Access Compliance Report

Public Rights-of-Way

(Curb Ramps)

Intersection ID: 28655	Main Street: HAMPTON_PLACE_DR	Cross Street: KEELS_CT	Location:	NW
ADA ID: C87FED47DBA9	Ramp Type: BlendTrans1	Initial Pass/Fail: Fail	Overall Compliance: No	Severity Score: 10
Codes/Mitigation Info/Possible Solution		Field Measurements/Component Compliance

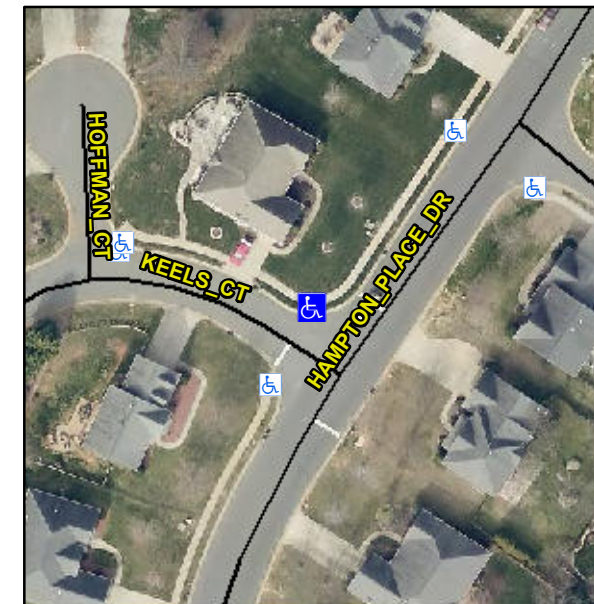
Compliance	Description	Data	Compliance	Description	Data
N/A	Ramp Length (in)	51.0	Yes	BlendTrans Slope (%)	4.8
No	Ramp Width (in)	47.4	No	BlendTrans XSlope (%)	2.4
N/A	Flare Type LT	N/A	N/A	Flare Type RT	N/A
N/A	Flare Slope LT (%)	N/A	N/A	Flare Slope RT (%)	N/A
N/A	Flare Traversable LT?	N/A	N/A	Flare Traversable RT?	N/A
N/A	Landing Length (in)	N/A	N/A	DWS Provided?	N/A
N/A	Landing Width (in)	N/A	N/A	DWS Contrast?	N/A
N/A	Landing Slope (%)	N/A	N/A	DWS Length (in)	N/A
N/A	Landing X Slope (%)	N/A	N/A	DWS Full Width?	N/A
N/A	Landing Curb? (Y/N)	N/A	N/A	DWS Offset (in)	N/A
N/A	Shared Landing?	N/A			
N/A	Gutter Ponding?	N/A	N/A	Gutter Slope (%)	N/A
N/A	Gutter Lip Ht (in)	N/A	N/A	Gutter X Slope (%)	N/A
N/A	Painted X Walk1?	No	N/A	Painted X Walk2?	N/A
	X Walk 1 Direction	To SW		X Walk 2 Direction	N/A
	X Walk 1 Width (in)	N/A		X Walk 2 Width (in)	N/A
	X Walk 1 Slope (%)	1.6		X Walk 2 Slope (%)	N/A
	X Walk 1 X Slope (%)	0.4		X Walk 2 X Slope (%)	N/A

N/A	Ramp inside XWalk1?	N/A	N/A	Ramp inside XWalk2?	N/A
	Road Slope (%)	0.4		Clear Space?	N/A
	Road X Slope (%)	1.6	N/A	Clear Space to XWalk (in)	N/A
N/A	Any Obstructions?	N/A	N/A	Storm Grate/Utility Hazard?	N/A
	Obstruction Type			Storm Grate/Utility Type	
		N/A			N/A
			Yes	Surface Condition? (G/P)	Good
			N/A	Curb Slope (%)	2.1

Remove & Replace Curb Ramp With Two New Directional Ramps or Equivalent.
